Artesia Pump Station Improvements  
Solicitation Number: CO-00448-RL  
Job No.: 18-8603 and 14-6001

ADDENDUM 2  
July 23, 2021

SHEET **M-10-102**  
14 OF 38

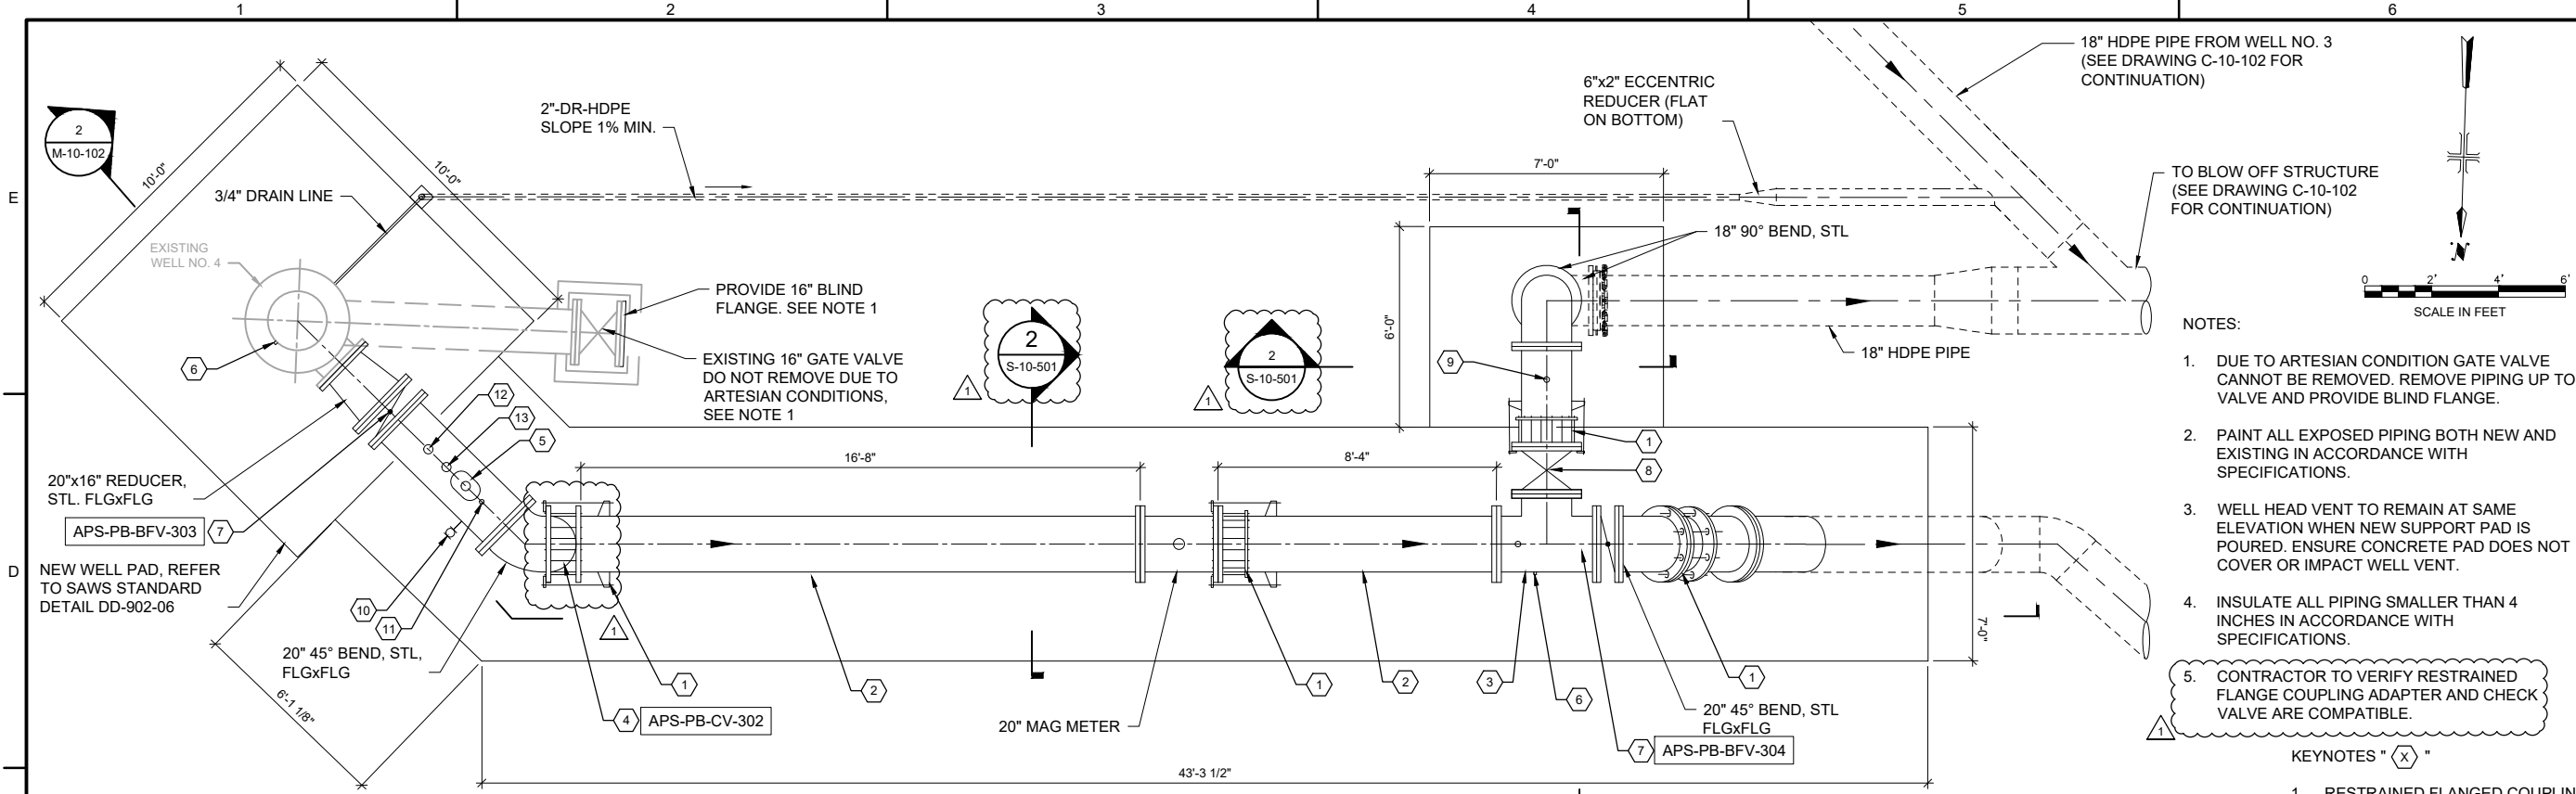
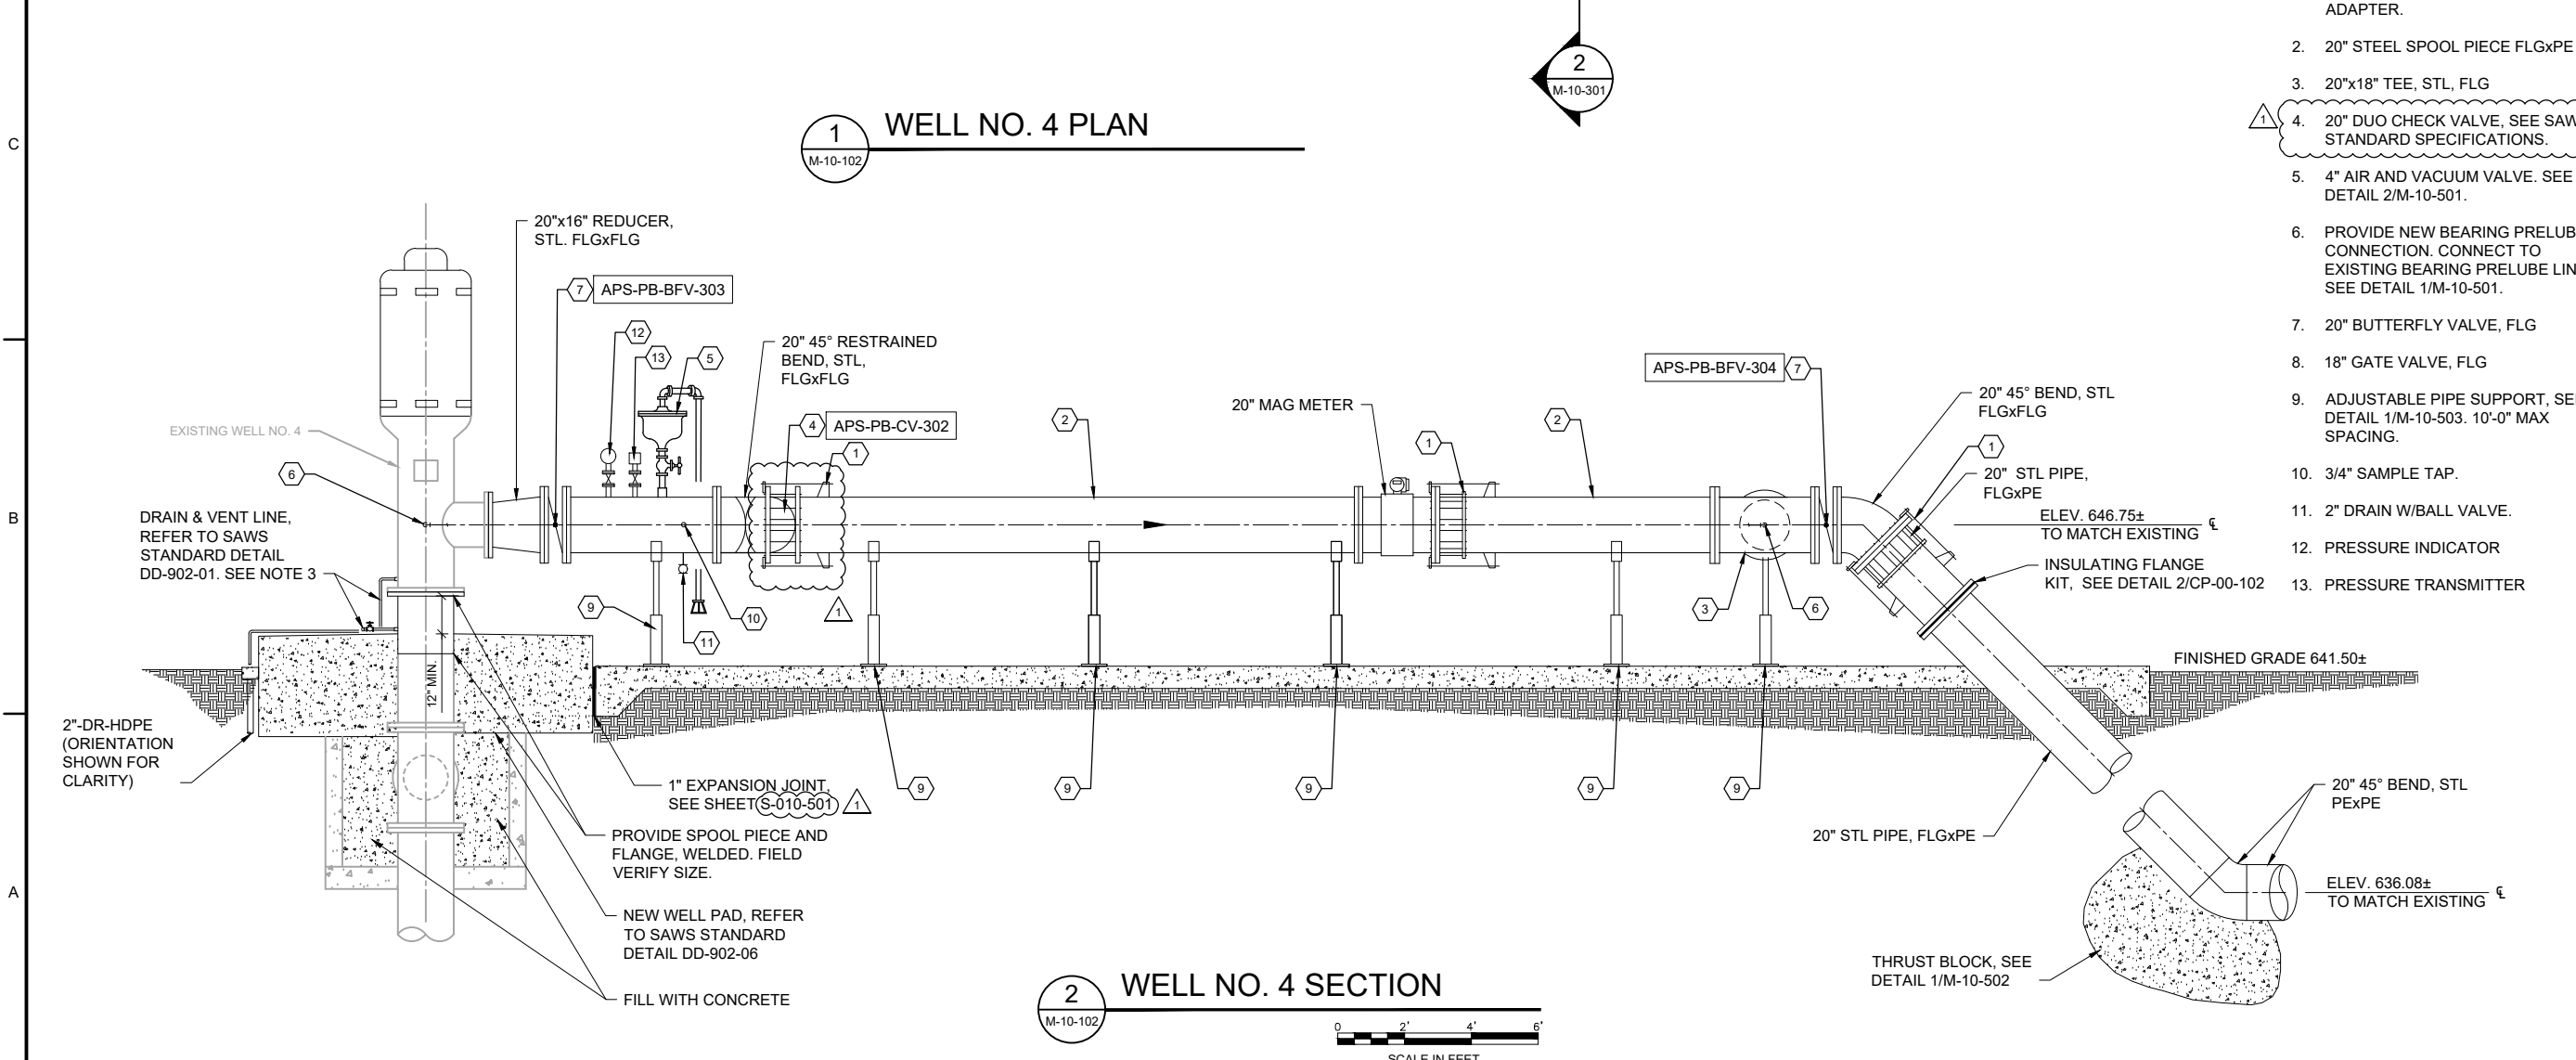
16. Delete Volume 2 – Sheet 13 (M-10-101) and Replace with the revised Sheet in this Addendum included as Attachment 4.
17. Delete Volume 2 – Sheet 14 (M-10-102) and Replace with the revised Sheet in this Addendum included as Attachment 5.

**1 WELL NO. 5 PLAN**

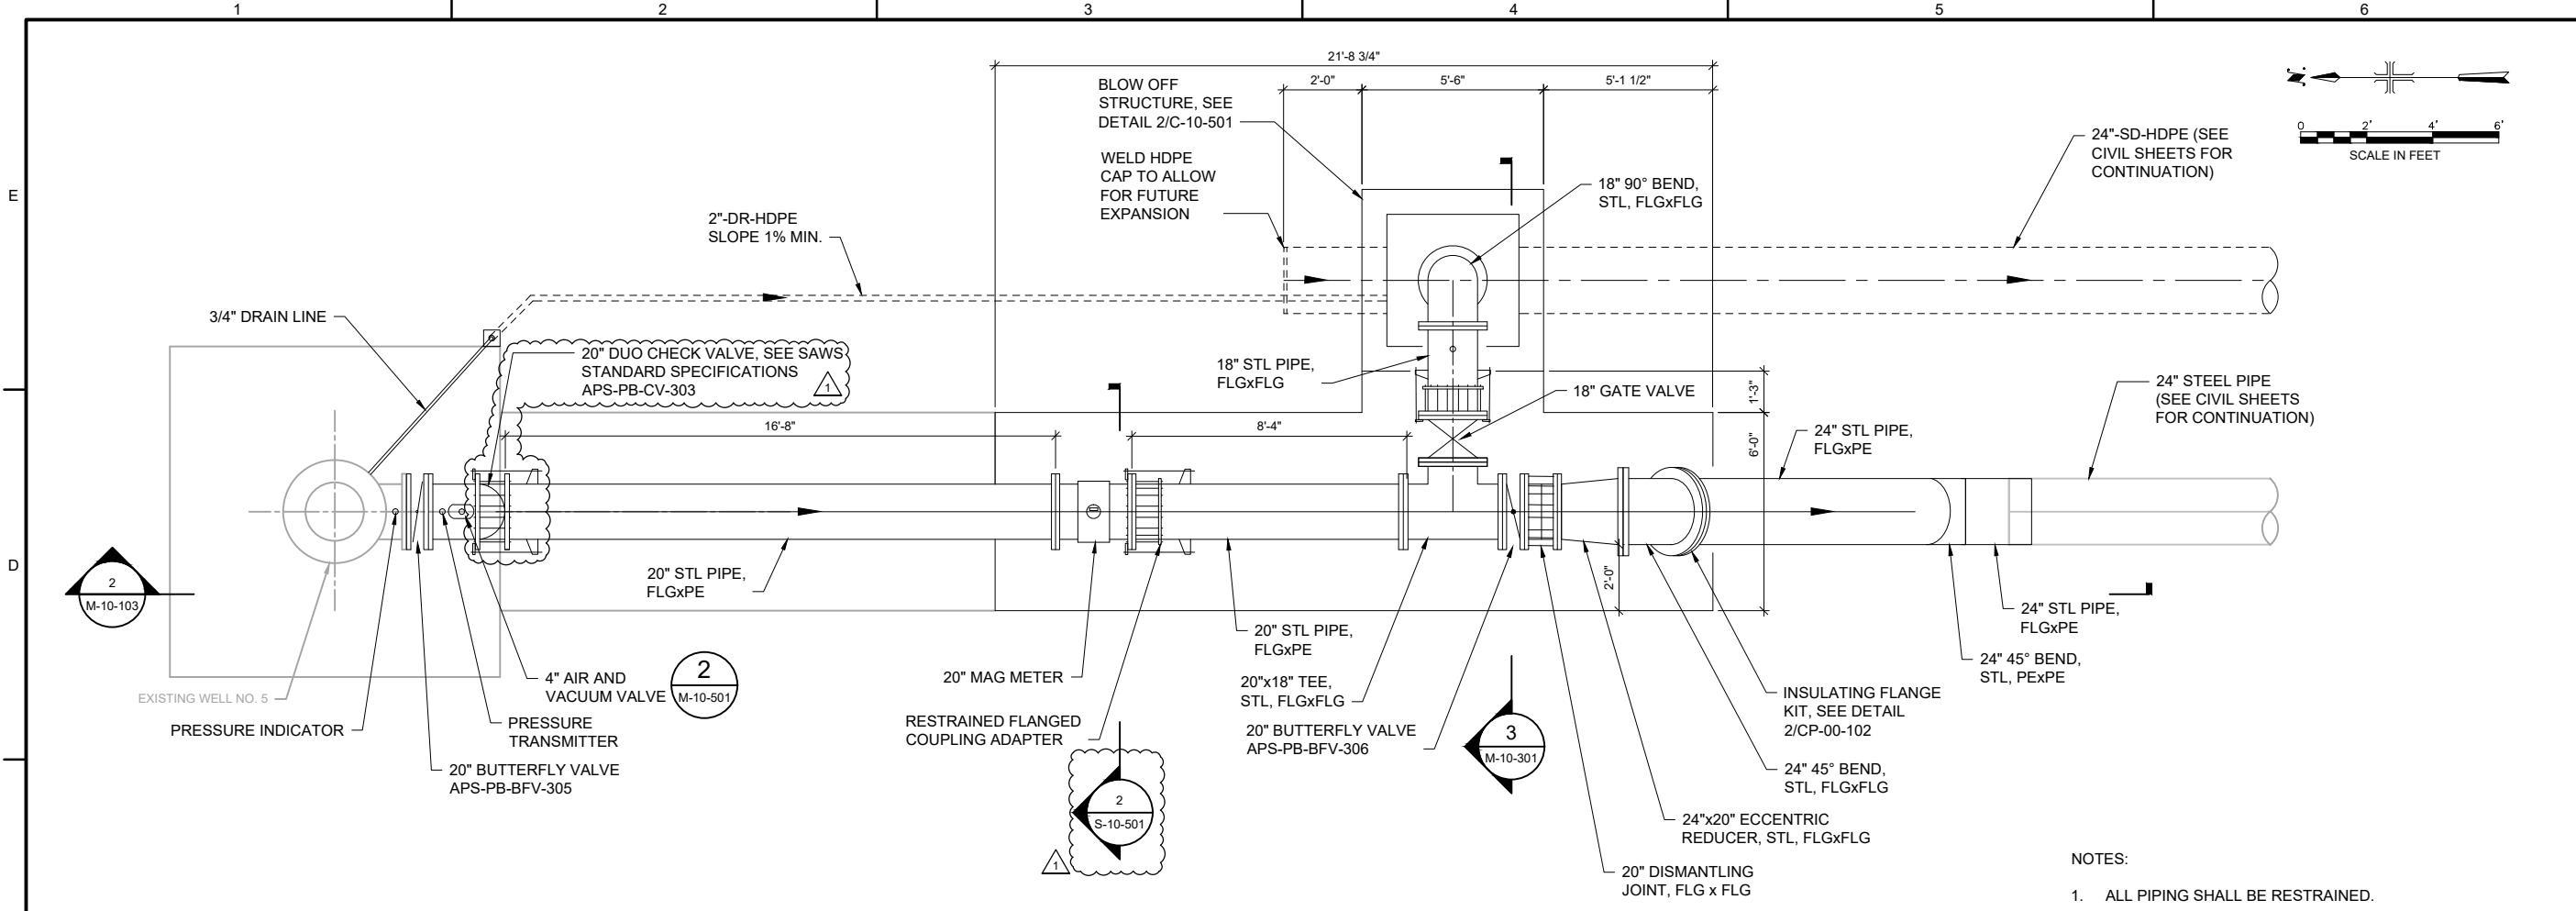
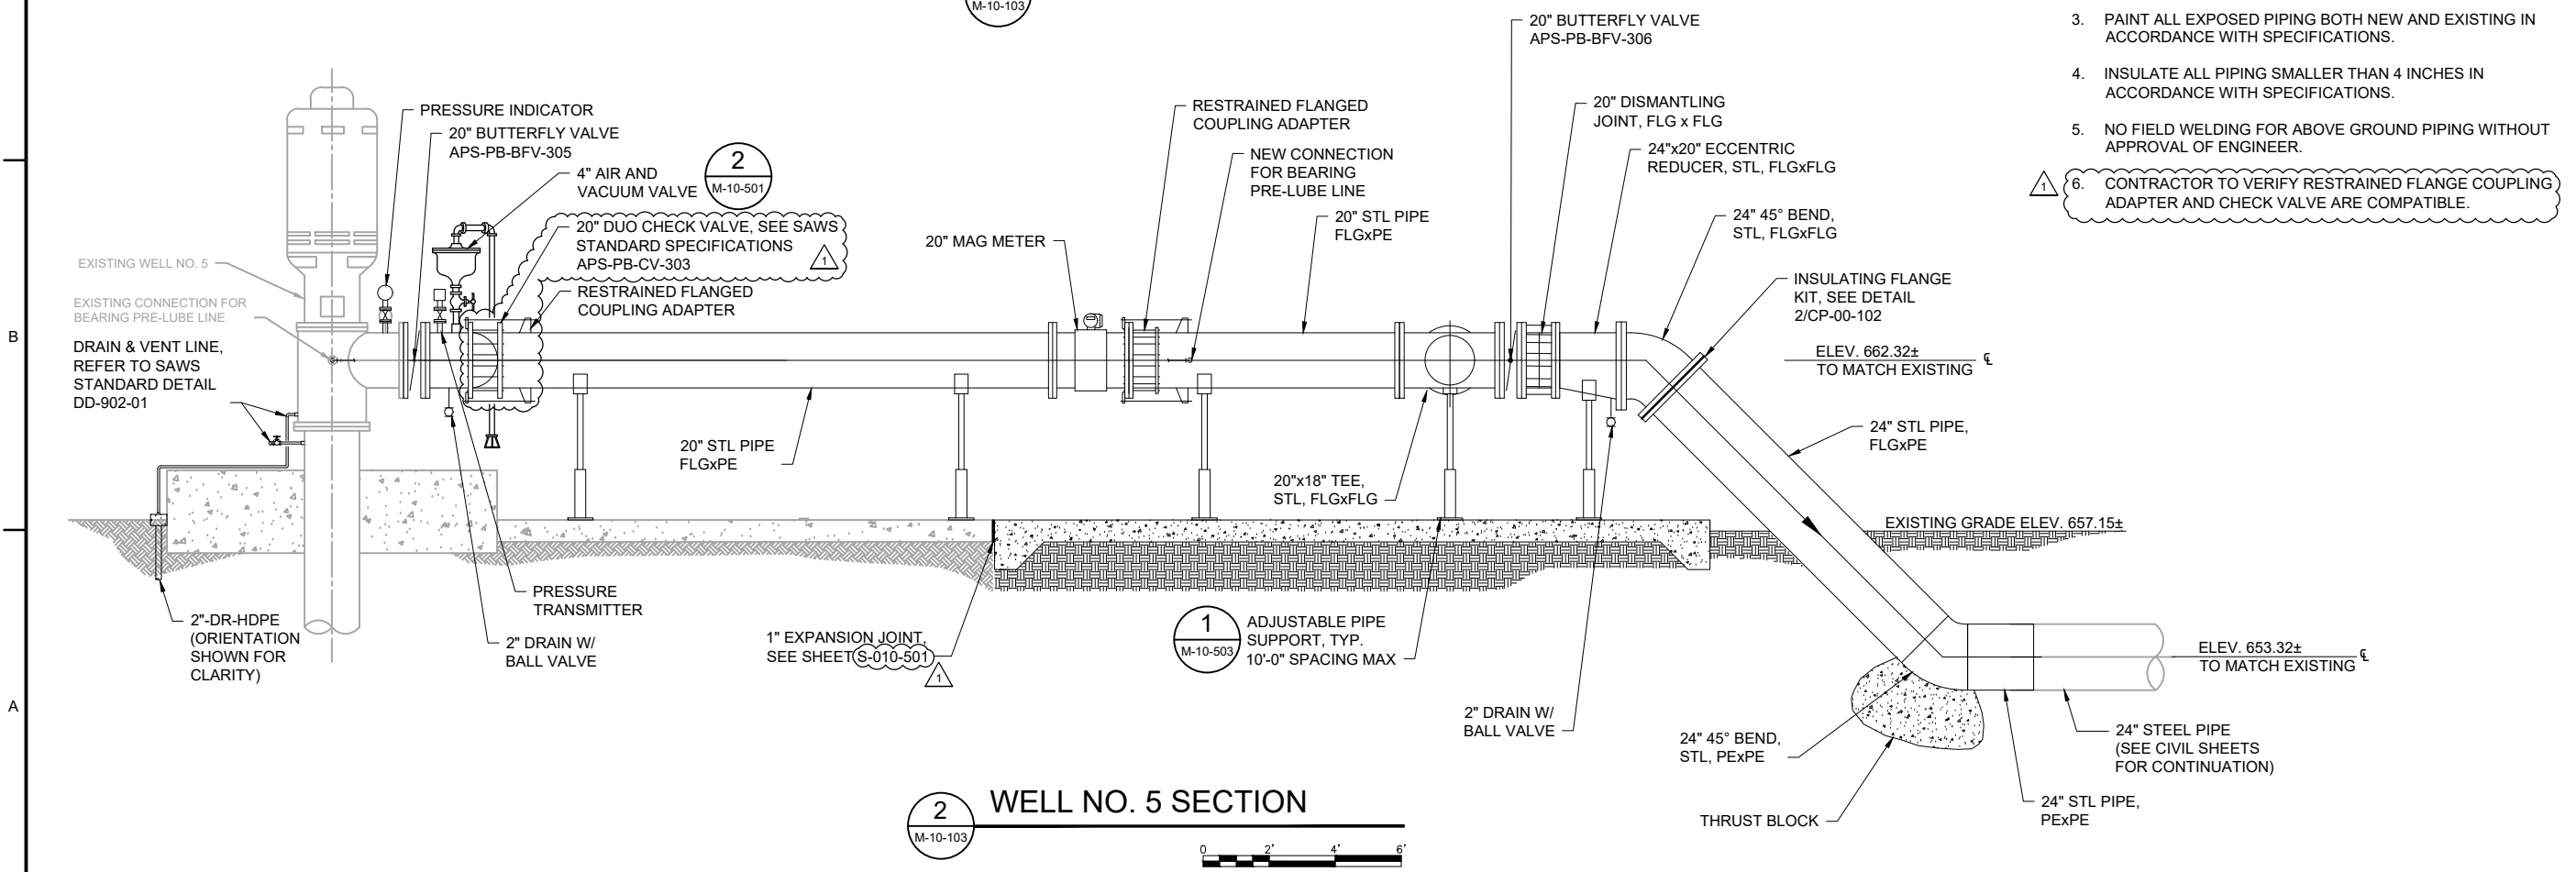
18. Delete Volume 2 – Sheet 15 (M-10-103) and Replace with the revised Sheet in this Addendum included as Attachment 6.
